SUBDIVISION COMMITTEE
METROPOLITAN AREA PLANNING COMMISSION

STAFF REPORT
(Preliminary Plat)

CASE NUMBER: SUB 2003-111 -- MY HOUSE ADDITION

STAFF REPORT
(Final Plat, Preliminary Plat Approved 10/16/03)

VICINITY MAP

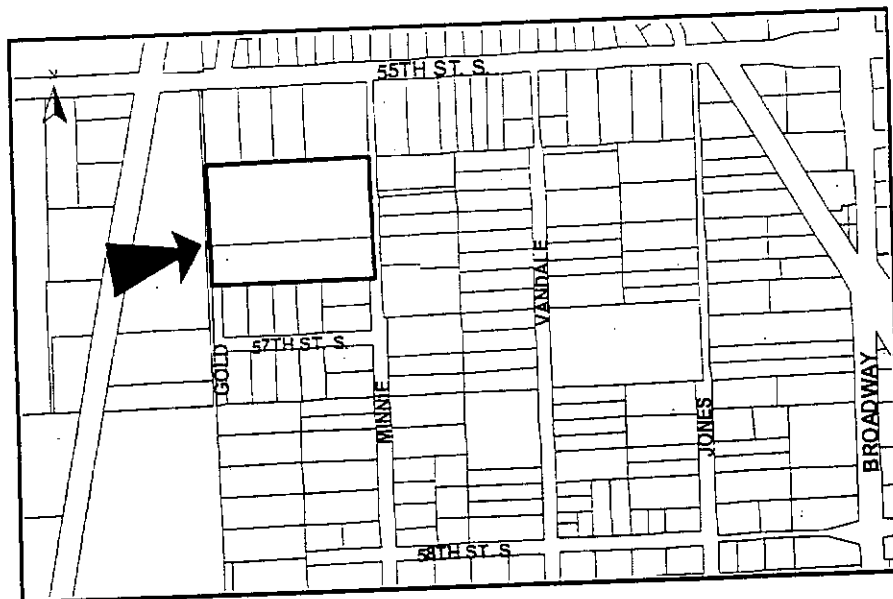
- A. The applicant shall guarantee the extension of sanitary sewer and City water to serve the lots being platted. City Engineering needs to comment on the need for other guarantees or easements.

- C. City Engineering needs to comment on the status of the applicant's drainage concept.
- D. The Applicant shall guarantee the paving of the proposed streets.

- E. MAPD and Traffic Engineering recommend the Applicant provide a 40-foot dedication of street right-of-way along the west property line in order to provide potential street connection to adjoining properties. The cul-de-sacs should be extended to this 40-foot street dedication.

- F. Since this plat proposes the platting of narrow street right-of-way with adjacent "15-foot street drainage and utility easements", a restrictive covenant shall be submitted which calls out restrictions for lot-owner use of these easements. Retaining walls and change of grade shall be prohibited within these easements as well as fences, earth berms and mass plantings.

- G. The applicant shall submit a covenant which provides for four (4) off-street parking spaces per dwelling unit on each lot which abuts a 32-foot street. The covenant shall inventory the affected lots by lot and block number and shall state that the covenant runs with the land and is binding on future owners and assigns.

- I. GIS needs to comment on the plat's street names. W. 56th St. S. Circle shall be revised to "W 56th Cir S". Wayne Circle shall be denoted as Wayne Cir.

- J. The applicant shall submit a copy of the instrument which establishes the pipeline easements on the property, which verifies that the easements shown are sufficient and that utilities may be located adjacent to and within the easements. Any relocation, lowering or encasement of the pipeline, required by this development, will not be at the expense of the City.

- K. On the final plat, reference to the "50-ft building setback" shall further note that the setback line is a Building Setback Line for the STG, Inc. Pipeline.

VICINITY MAP

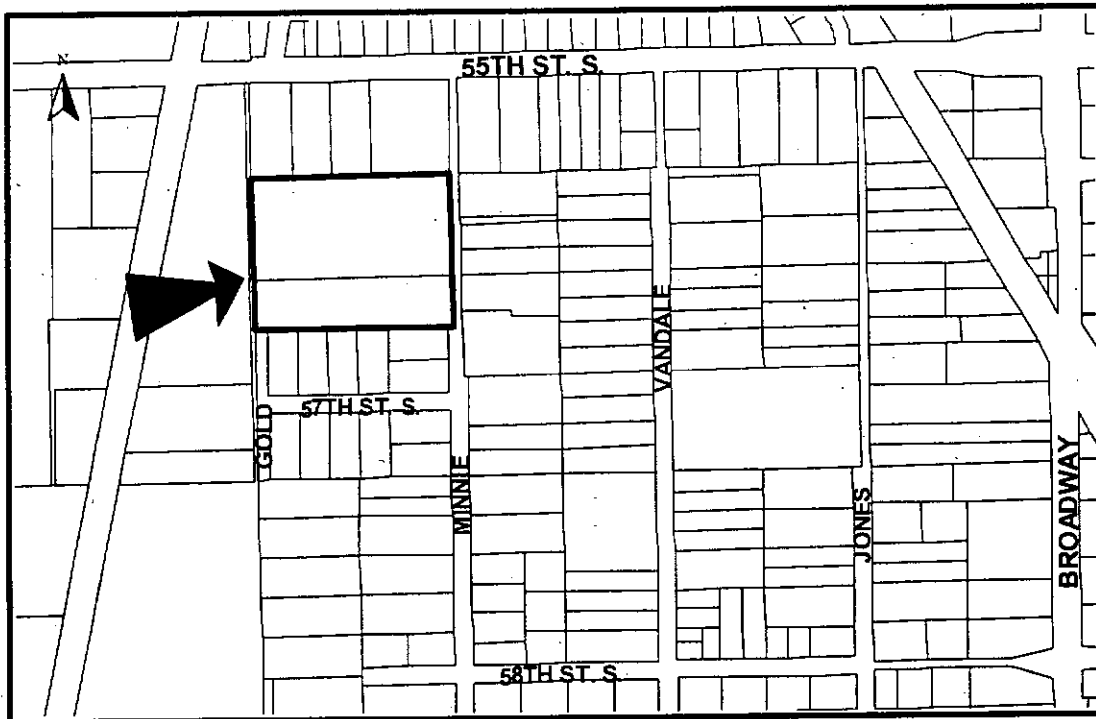
- A. The applicant shall guarantee the extension of sanitary sewer and City water to serve the lots being platted.
- B. If improvements are guaranteed by petition, a notarized certificate listing the petitions shall be submitted to the Planning Department for recording.
- C. City Engineering needs to comment on the status of the applicant's drainage plan. **An off-site drainage easement is needed.**
- D. The Applicant shall guarantee the paving of the proposed streets.
- E. MAPD and Traffic Engineering recommend the Applicant provide a 40-ft dedication of street right-of-way along the west property line in order to provide potential street connection to adjoining properties. The cul-de-sacs should be extended to this 40-ft street dedication.

- F. Since this plat proposes the platting of narrow street right-of-way with adjacent "15-foot street drainage and utility easements", a restrictive covenant shall be submitted which calls out restrictions for lot-owner use of these easements. Retaining walls and change of grade shall be prohibited within these easements as well as fences, earth berms and mass plantings.

- G. The applicant shall submit a covenant which provides for four (4) off-street parking spaces per dwelling unit on each lot which abuts a 32-foot street. The covenant shall inventory the affected lots by lot and block number and shall state that the covenant runs with the land and is binding on future owners and assigns.

- I. GIS needs to comment on the plat's street names. **W 56th S needs to be revised to "W 56th Cir S".**
- J. The applicant shall submit a copy of the instrument which establishes the pipeline easements on the property, which verifies that the easements shown are sufficient and that utilities may be located adjacent to and within the easements. Any relocation, lowering or encasement of the pipeline, required by this development, will not be at the expense of the City.

- K. On the final plat, reference to the "45-ft building setback" shall further note that the setback line is a Building Setback Line for the STG, Inc. Pipeline.

The street dedication has been platted as requested.
